## Design Statement

The application seeks consent for non-material amendments to planning application Ref: 2021/1815/P, granted consent on 28 June 2021.

1 Existing Front Elevation  
Scale: 1:50

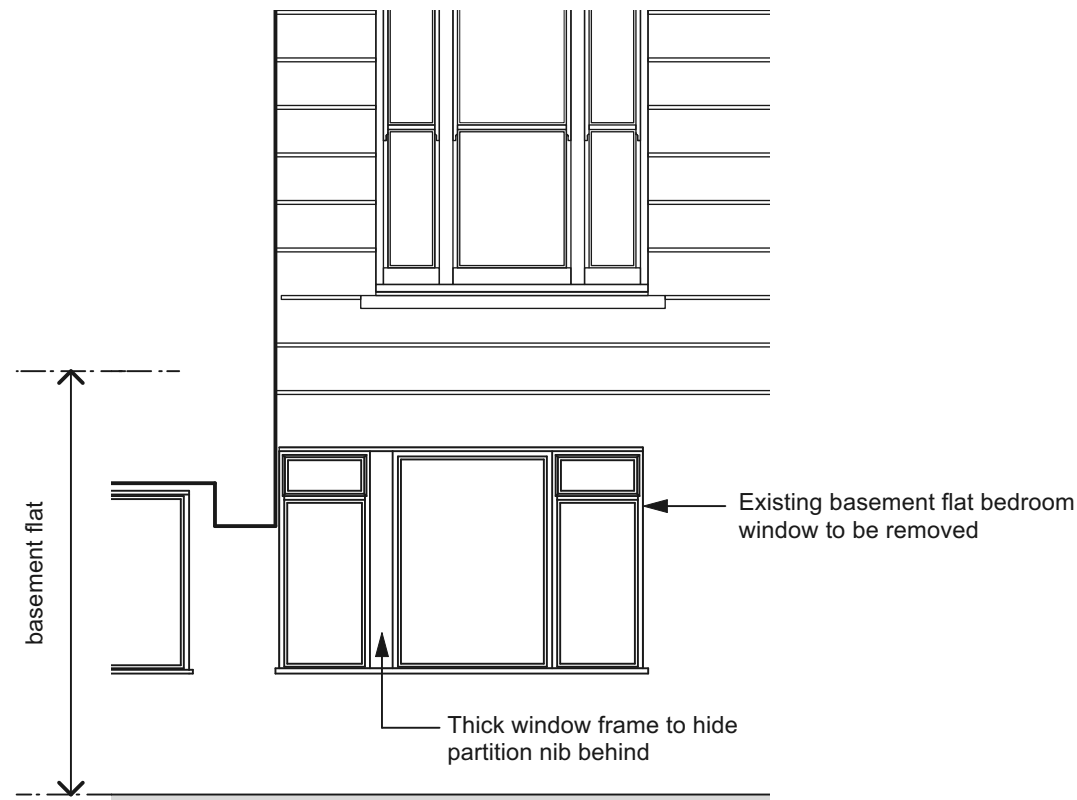
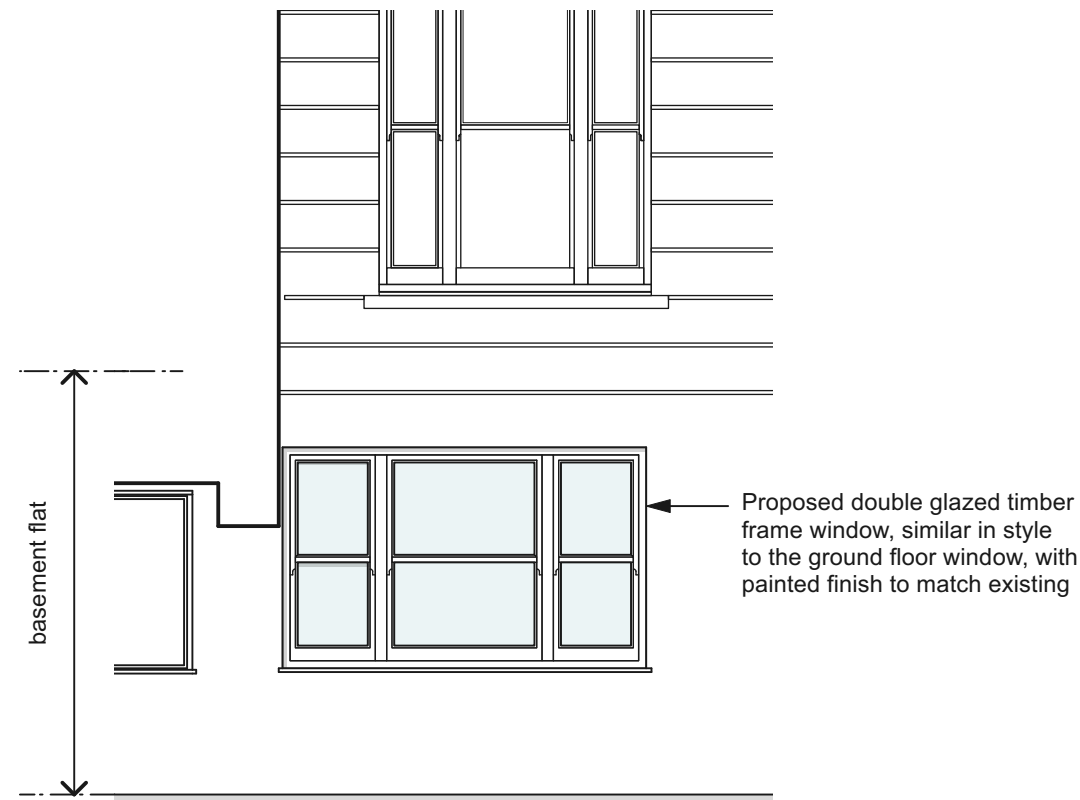
- Removal of the front lightwell single glazed timber window and partition nib
- Replace with a timber double glazed window styled similar to the ground floor front window

The work is necessary to replace the single glazed window which is in a poor condition and has poor thermal properties. The window had been modified with a partition nib that once provided natural light to two bedrooms. The nib to be removed as it is no longer required. The style of the proposed replacement window is in keeping with immediate and wider historical context.
